ORIGINATION FORM

Proposed Revisions to a Standard Plans Index

Index Number: 443-001

Index Title: French Drain

LAST REVISION 11/01/23	DESCRIPTION:	 FY 2024-25 STANDARD PLANS	FRENCH DRAIN	INDEX 443-001	SHEET 2 of 3
---------------------------	--------------	---	---------------------	-------------------------	------------------------

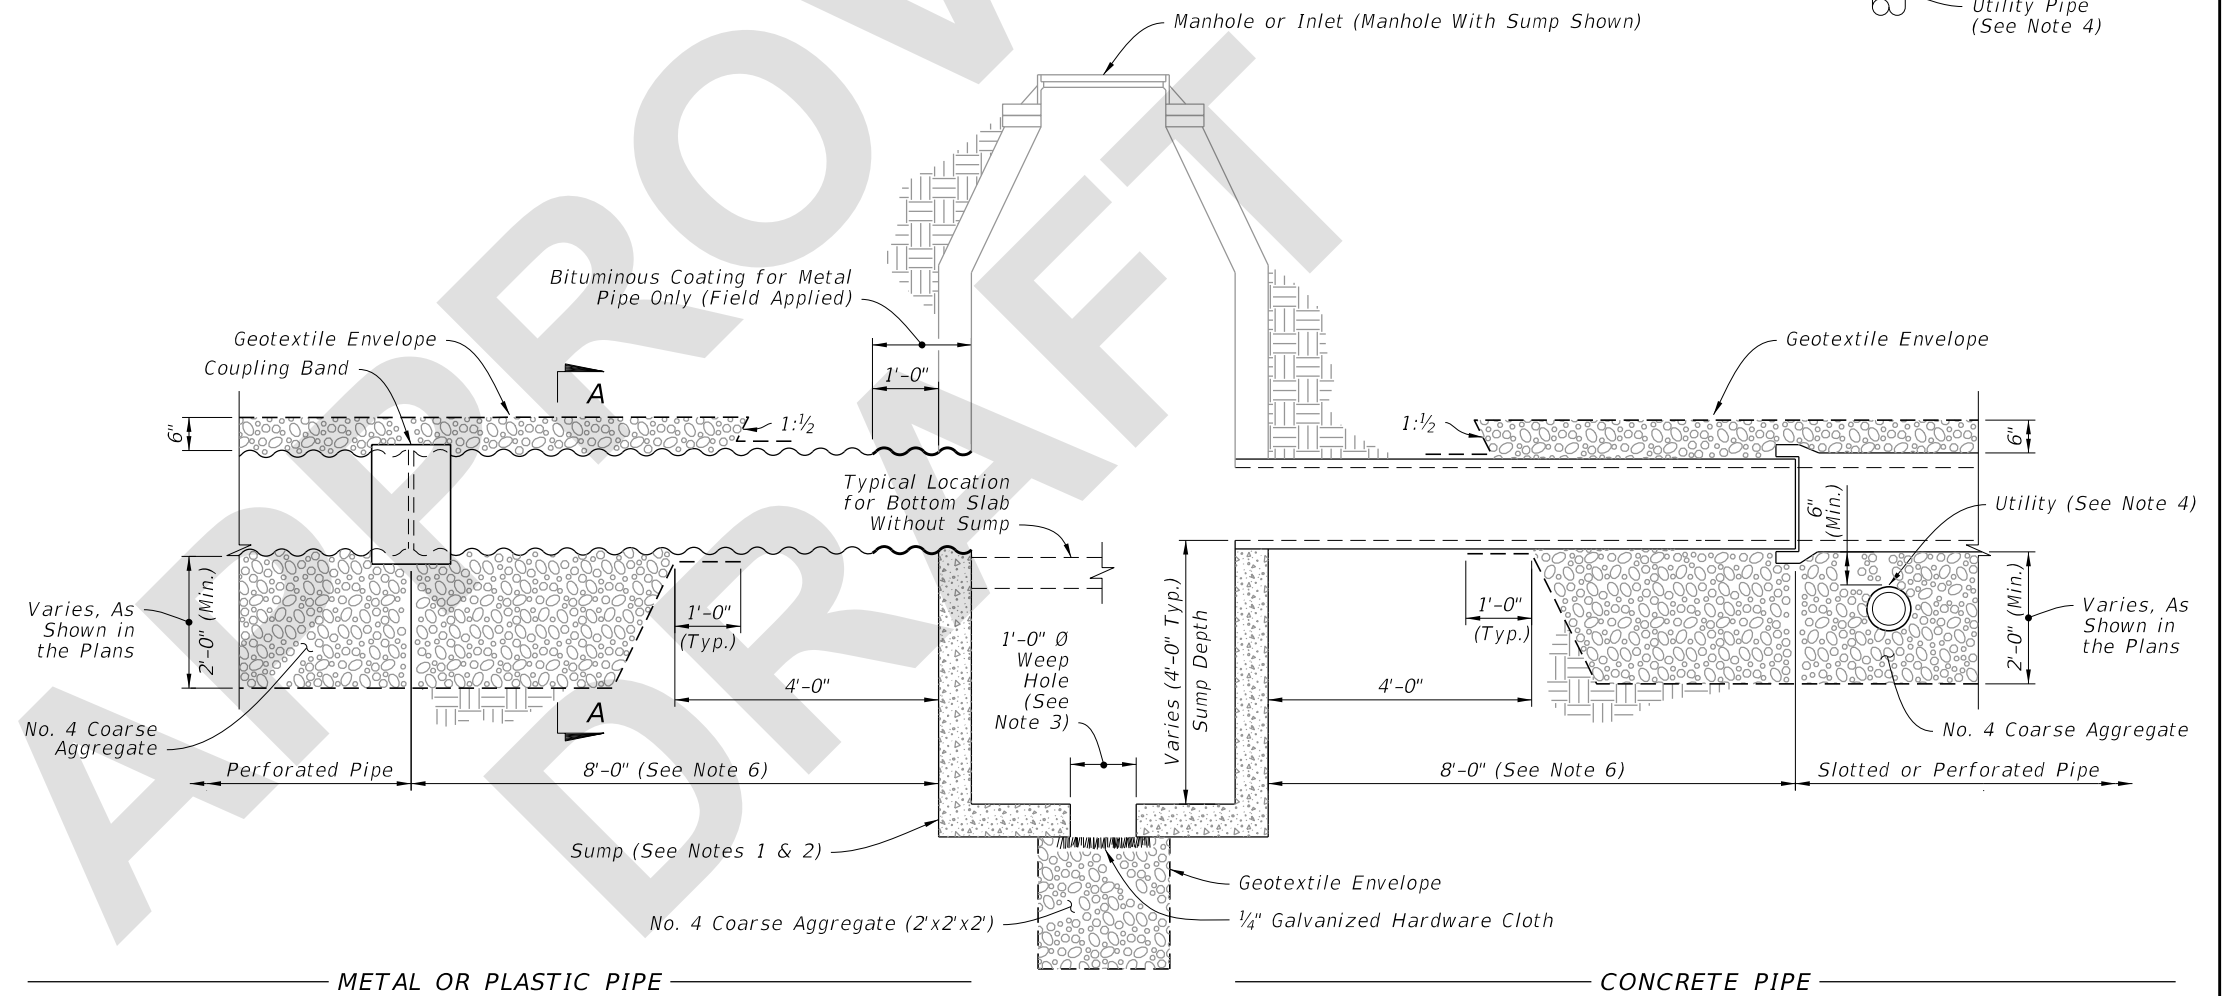
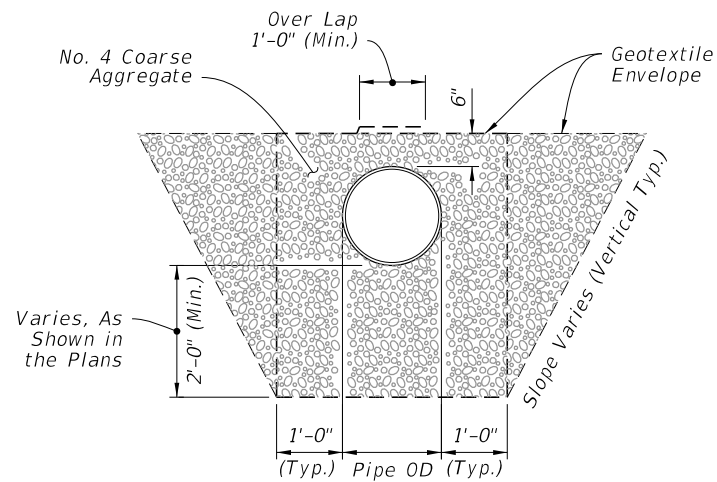
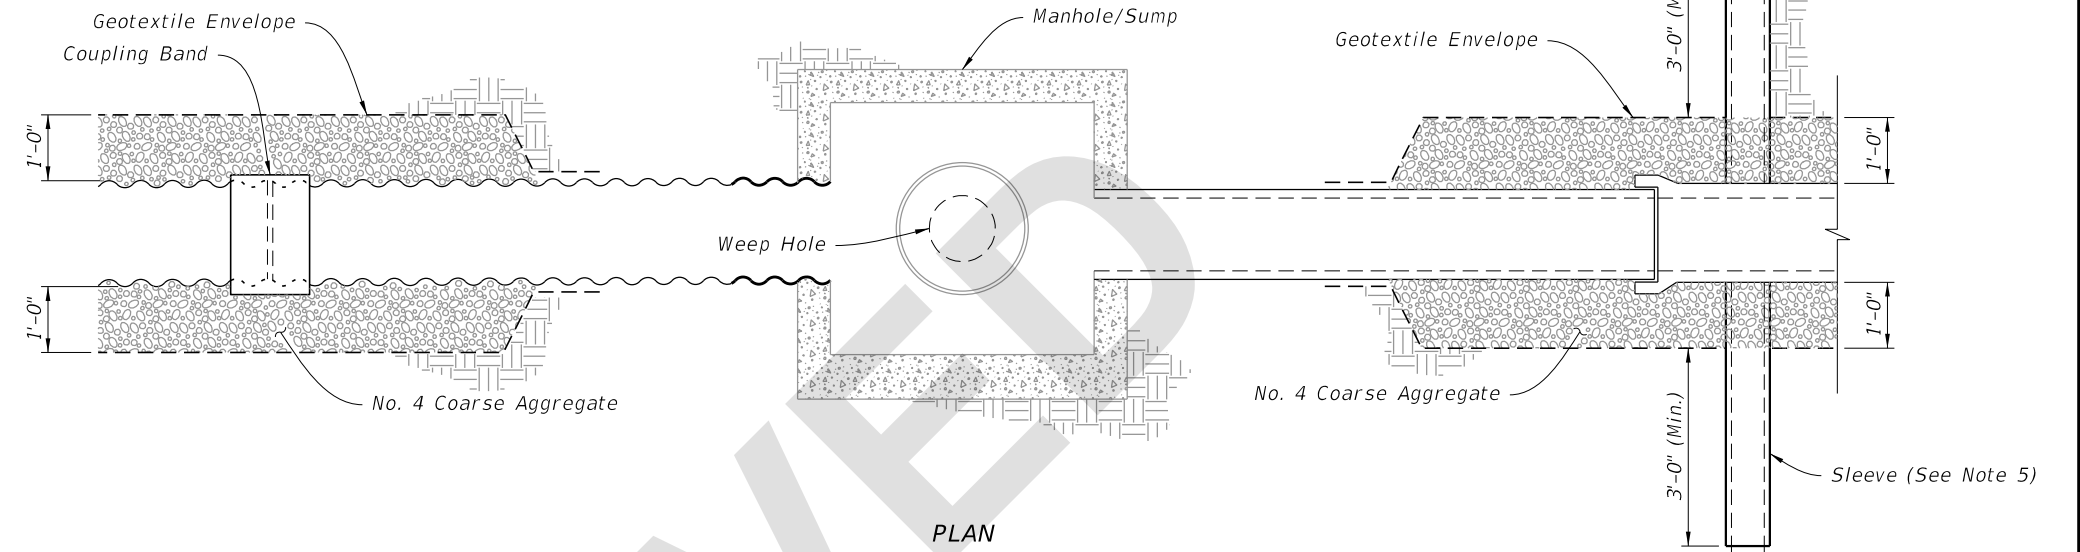
Sheet 2: Changed all references of "Filter Fabric" to "Geotextile".
